### Amendments/Additional Information

Reply to your letter dated 21.09.16 Ref: NYM/2016/0495/FL

**Construction of Workshop/Studio Building at Brooklea, Fylingthorpe**

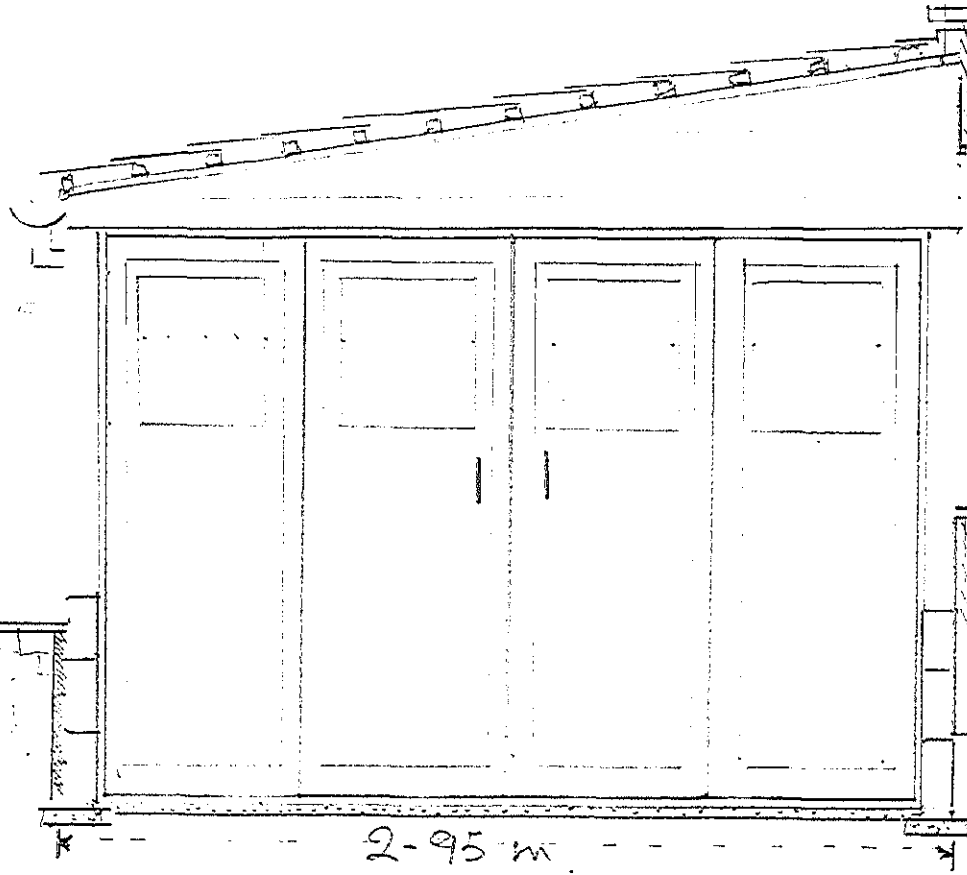
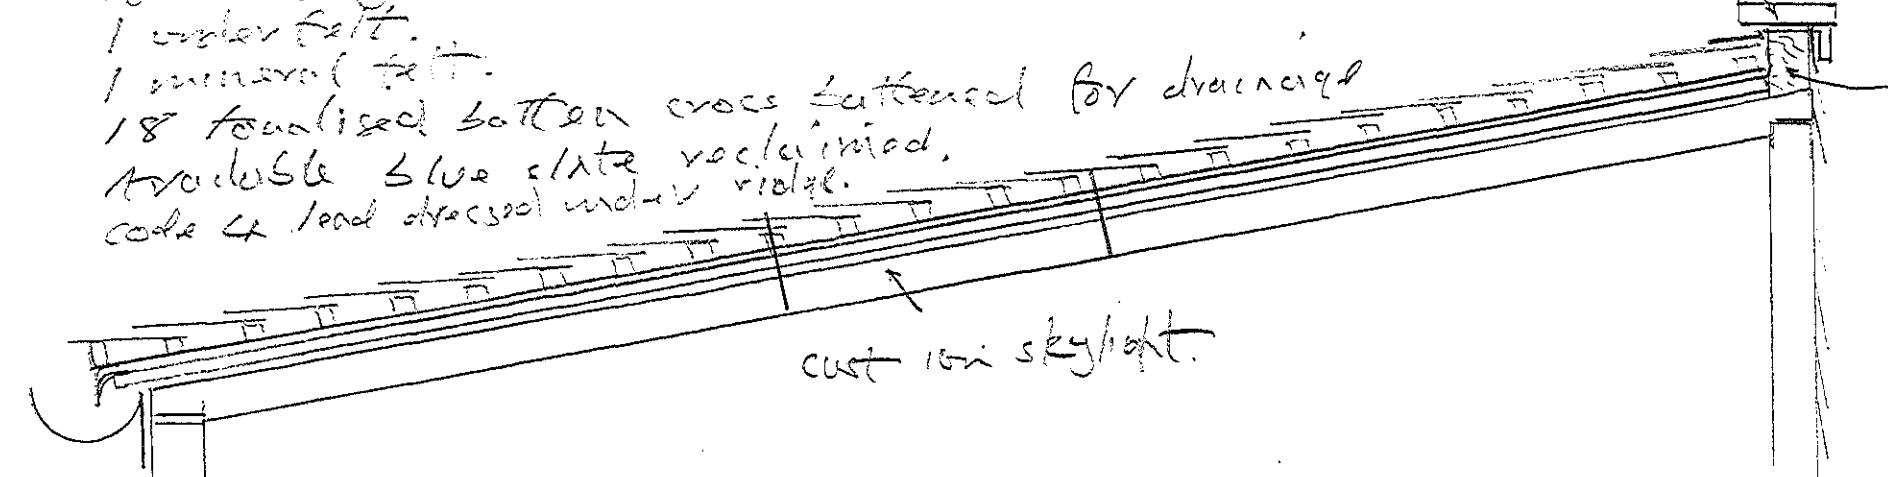
1/ I am quite happy to change the roofing material for slate. I cannot see any reasonable objection to the bifold wooden doors or the shiplap cladding and windows above the small area of lime render. All wall panels 100mm, frame and cladding 30mm. By not using Perspex roofing, I will be losing good natural light. I will substitute with the use of two old cast iron roof lights approximately 18 by 24 inches each. Because of the shallow pitch of the roof, I will have to board the roof with 18mm ply with felt waterproofing, double lathe for drainage then second hand blue slates. Code 4 lead flashing around roof lights and dressed under ridge. Shed is approximately 30cms below garden level.

7/ Checking my measurements. Length: 4.85m, Width: 2.95m, Height: front 2.5m, Height: back 2.00 m. Apologies I had 2.85m width previously.

100 mm rafter,  
 18 mm ply,  
 1 under felt,  
 1 mineral felt.

18 tanalised batten cross battened for drainage  
 Available blue slate reclaimed,  
 code 4 lead dressed under ridge.
